Re: GCC Energy, LLC, King II Mine

CDRMS Permit # C-1981-035

King Coal I – Quarterly Water Quality Improvements Inspection

King Coal II - Quarterly Water Quality Improvements Inspection

Pic. 1 – Lower portion of Reach 10 at base/stilling basin of lower pile.

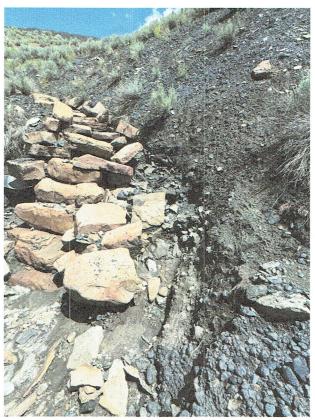
While most of the existing ditches and culverts appear to be generally in good condition, the treated water ditch (Reach 10) requires maintenance as a result of the recent storm event. The portion of Reach 10 adjacent to the haul road (east side) experienced flows which damaged the check dams installed to minimize flow velocities. The portion of the channel that flows into the stilling basin at the bottom of the lower waste embankment pile experienced some erosion as a result of the stormwater flows (see Pic. 1) and the channel section should be re-established. There was also some erosion of the channel section for Reach 10 where the culvert flows under the haul road at the base of the main waste embankment pile (see Pic. 2) which should be repaired to prevent excessive erosion in the event of a large storm event. There was also some visible erosion in the channel of the upper section of Reach 10 at the top of the waste embankment pile (see Pic. 3). Runoff bypassed the check dam at the top of the pile that

Pic. 3 – Erosion top of main waste pile (Reach 10), edge of check dam.

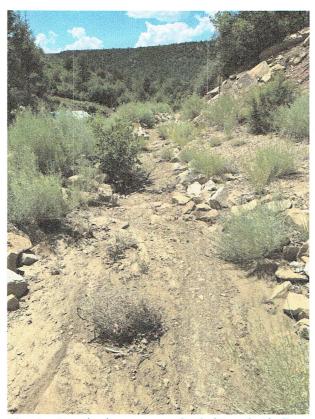
resulted in some erosion adjacent to the Reach 10 channel. The channel section should be improved to prevent runoff from running along the side of the channel.

Pic. 1 – Water level in the detention pond after storm event.

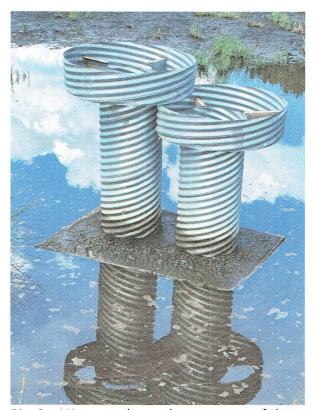
The site experienced a storm event on 6/27 which the Colorado Climate Center storm gauge at Fort Lewis registered almost 0.6 inches of rain. The storm produced intense rainfall over s short period of time. The water quality pond held more water than during the previous inspection (see Pic. 1). The elevation at the bottom of the pond could not be determined due to water within the pond. The current water levels make it difficult to assess the state of the sediment removal operations. It appears that some sediment had been removed has taken place since the previous inspection. Removal of sediment from the pond is on hold due to current water levels. Excess sediment should be removed from the detention pond as soon as site/weather conditions allow. The water is no longer isolated to the north side of the pond due to the recent storm event. Water currently stands around the outlet structure (see Pic. 2).
